3.0 LIMITING CONDITION FOR OPERATION (LCO) APPLICABILITY

The information in this section of the reference ABWR DCD, including all subsections, is incorporated by reference with the following departure.

STP DEP 16.3-1

Figure B 3.3.1.1-2 RCW/RSW HX Room Leak Detection Instrumentation Channels

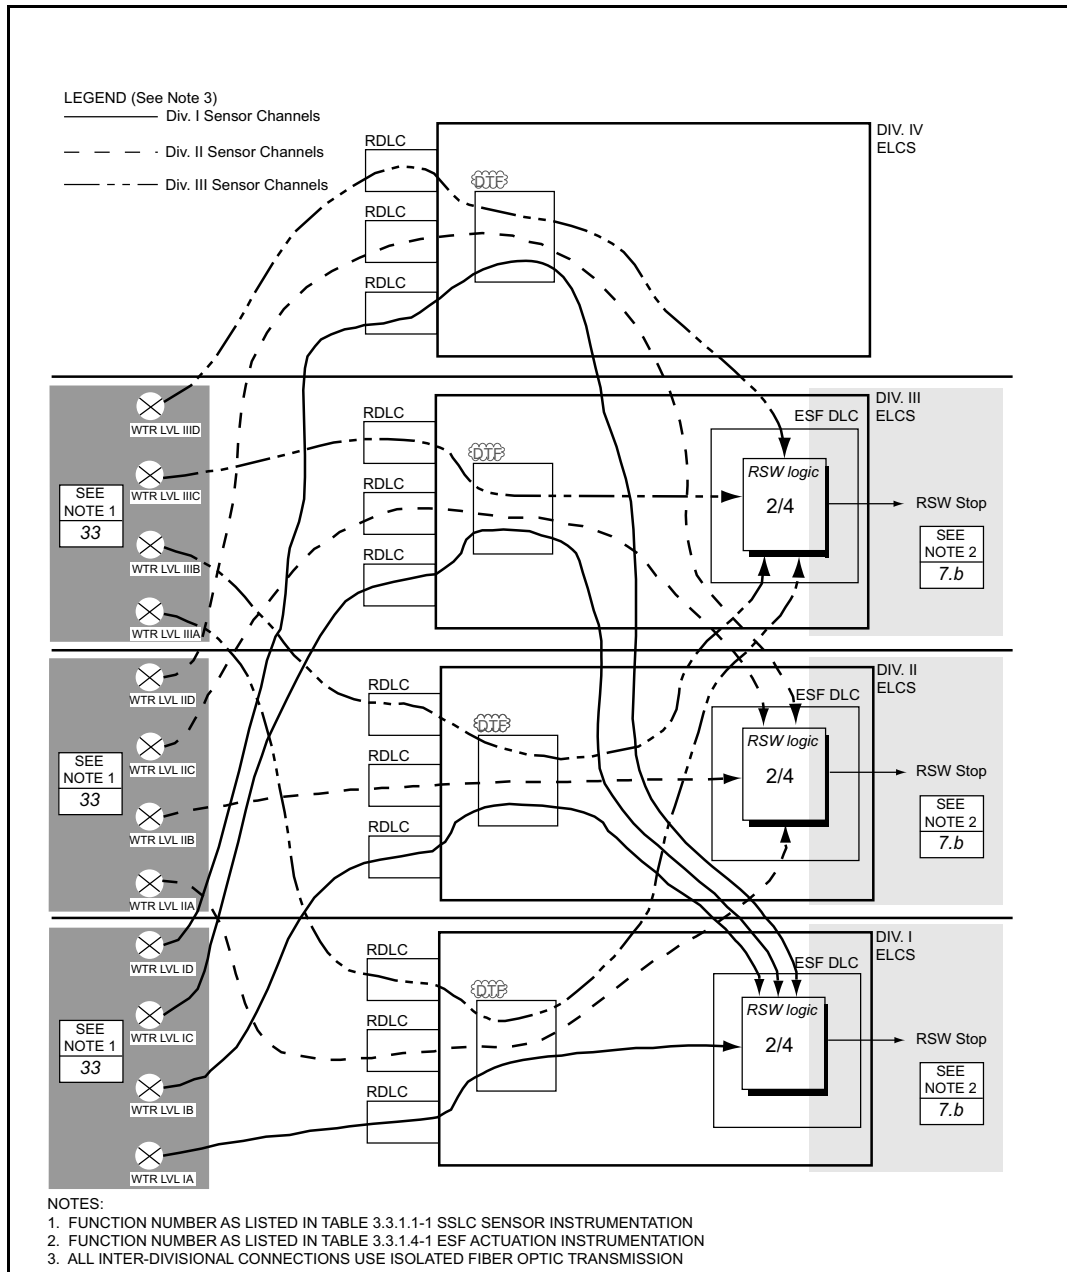
STD DEP T1 3.4-1

Figure B 3.3.1.4-1 ESF Actuation Channel Structure for Containment Isolation, ESF Support

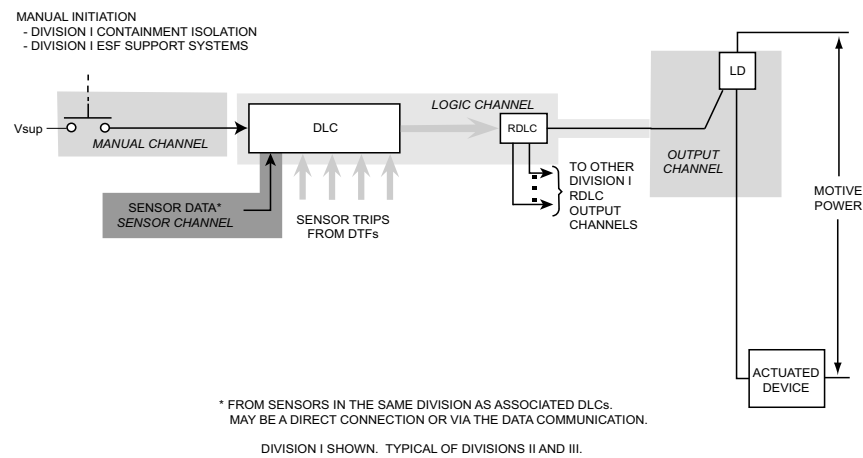
The channel structure for the channel types covered by this LCO are depicted in Figures B 3.3.1.4-1 through B 3.3.1.4-45. The channel structure in these Figures is similar with the basic structure as shown in Figure B 3.3.1.4-1. The channel characteristics shown in the ~~Figures Figure B-3.3.1.4-1~~ are:

STD DEP T1 3.4-1

Figure B 3.3.1.4-2 ESF Actuation Channel Structure for LPFL B, C, HPCF B, RCIC

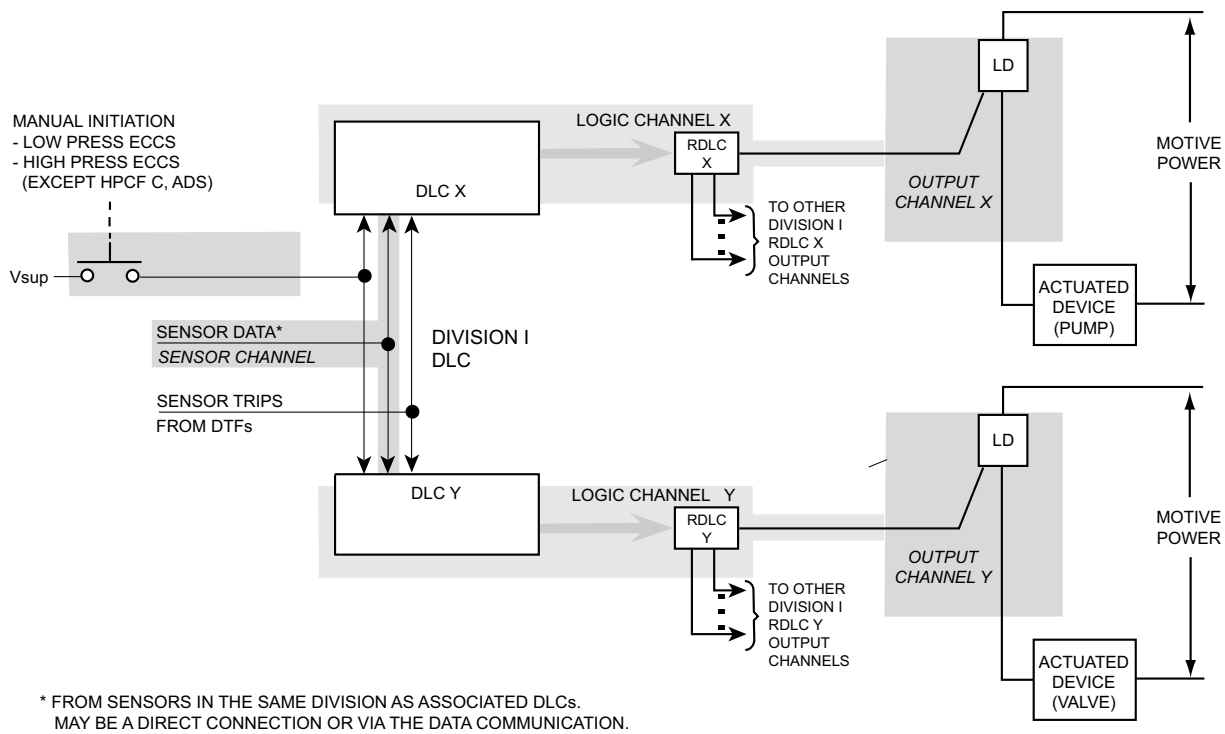
STD DEP T1 3.4-1

Figure B 3.3.1.4-3 ESF Actuation Channel Structure for HPCF C

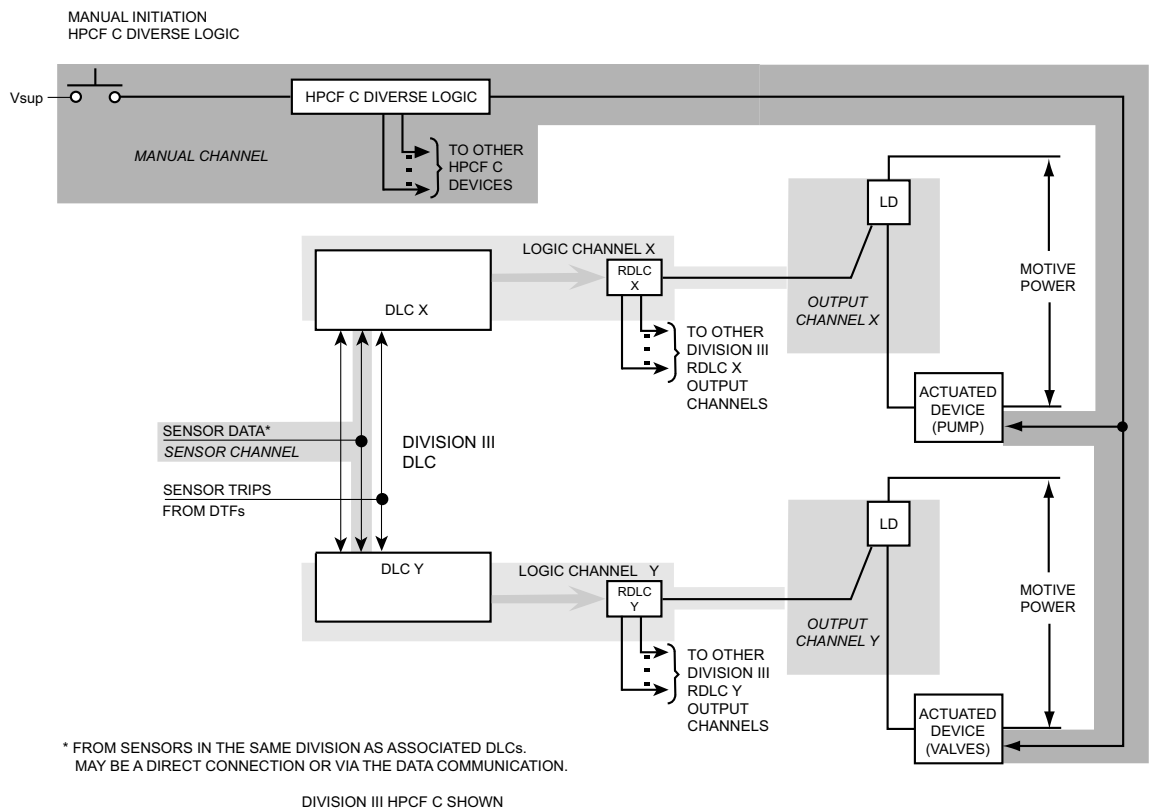
- Figure B 3.3.1.4-3 shows the hardwired manual channel for HPCF C diverse logic which applies only to division III.
- ~~The separate contacts from a~~ A single switch operator ~~are shown as~~ provides the manual initiation signal to ~~separate both~~ manual initiation channels, except HPCF C.

STD DEP T1 3.4-1

Figure B 3.3.1.4-4 ESF Actuation Channel Structure for ADS

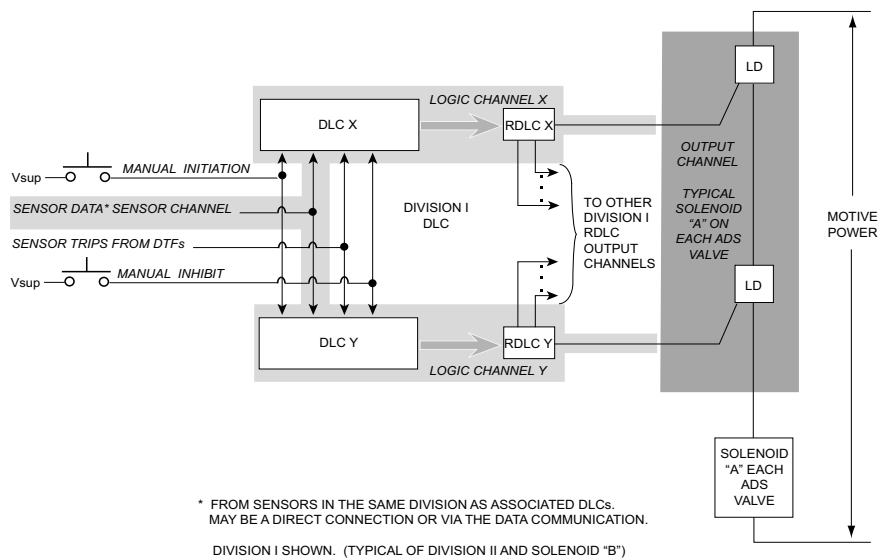
The ATWS Manual ADS Inhibit push button channels introduce signals into the ADS logic to provide manual ADS inhibit capability that is redundant to the automatic SENSOR CHANNELS. There is one push button for each ADS division trip system. ~~Each pushbutton has two contacts. Each member of the SLU pair~~ Both DLCs used to implement ADS within a division acquire data from ~~one of the contacts on the switch~~ in its division (see Figure B 3.3.1.4-4).

STD DEP T1 3.4-1

Figure B 3.3.1.4-5 ESF Actuation Channel Structure for RCW/RSW Isolation

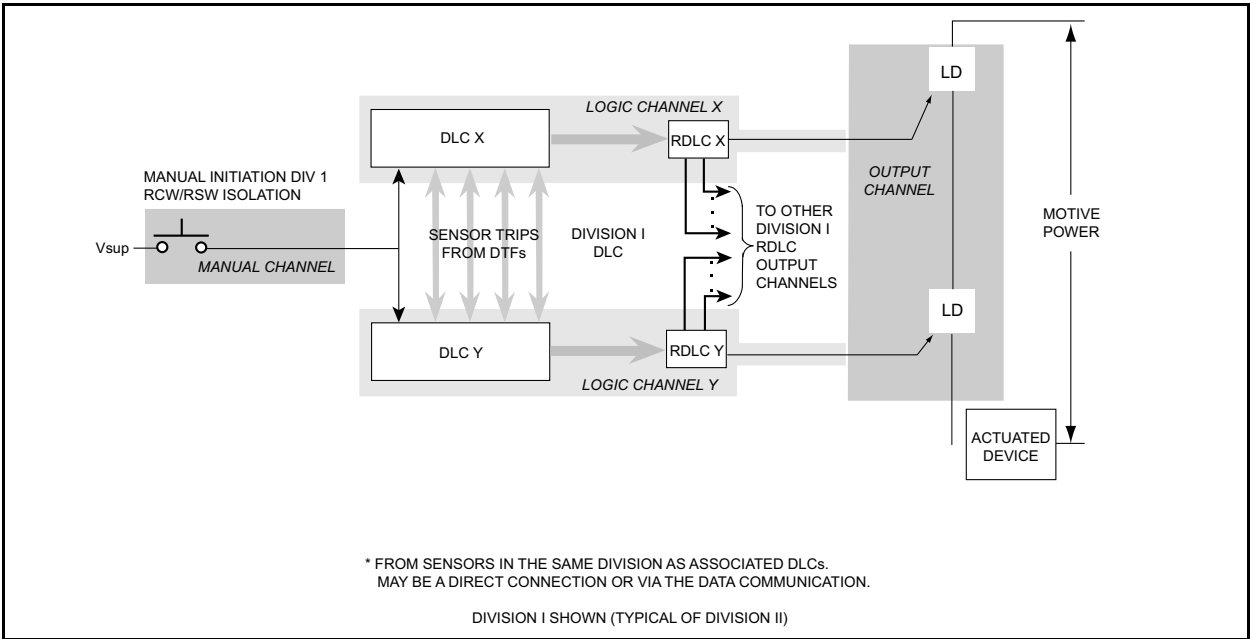
STD DEP T1 3.4-1

Figure B 3.3.4.1-1 ATWS and EOC-RPT Instrumentation Channels

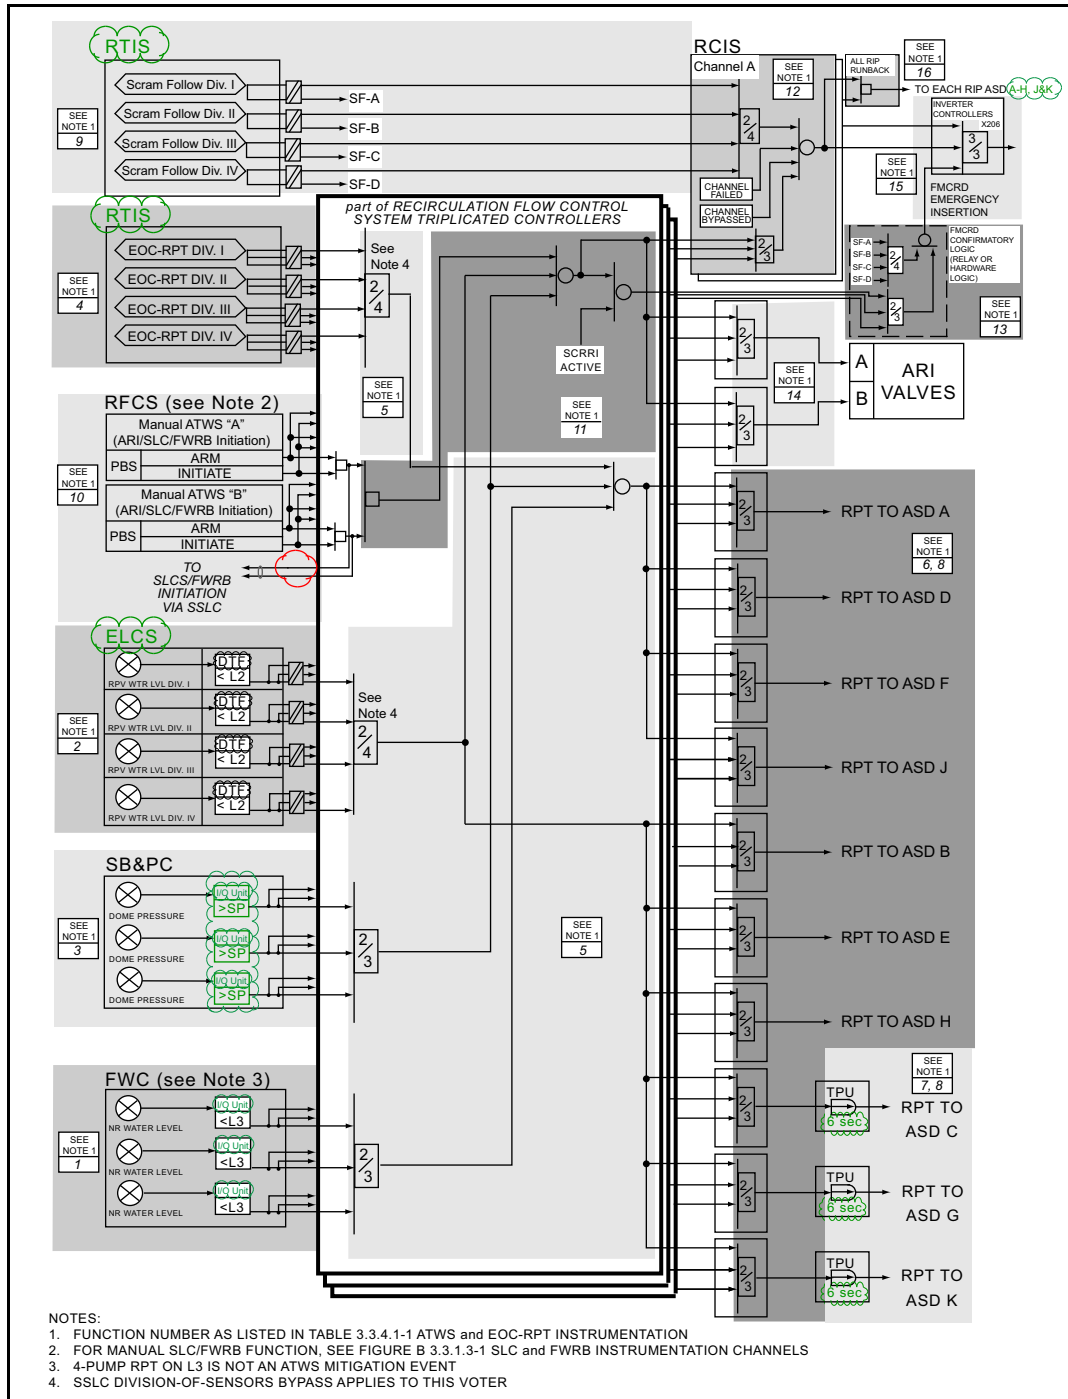
STD DEP T1 3.4-1
